Pedestrian Safety: Deflection of Bonnets in Active Pedestrian Protection Systems

UNECE GRSP Task Force Deployable Bonnet Systems for Pedestrian Safety
1st meeting, Paris, 7 - 8 February 2017

6 February 2017

Engine compartment of a large family car with a passive bonnet, bonnet lowered 80 mm (grey area), showing parts with intrusion:

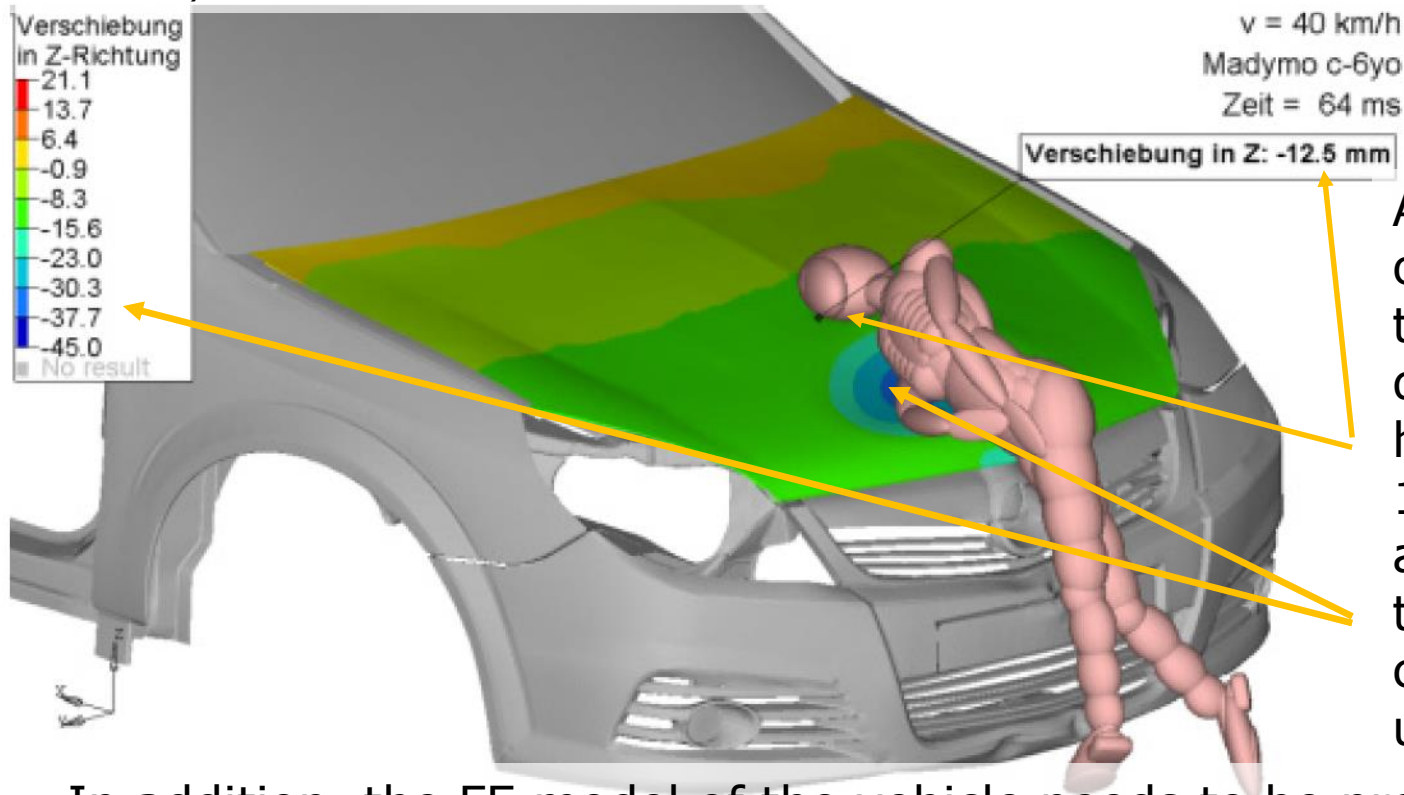
- Only dark-green parts are structural parts, most parts are rubber, plastics, composite materials etc.
- Many parts nowadays are attached so that they move away (e.g. brake fluid container), are collapsible (e.g. engine cover), etc.
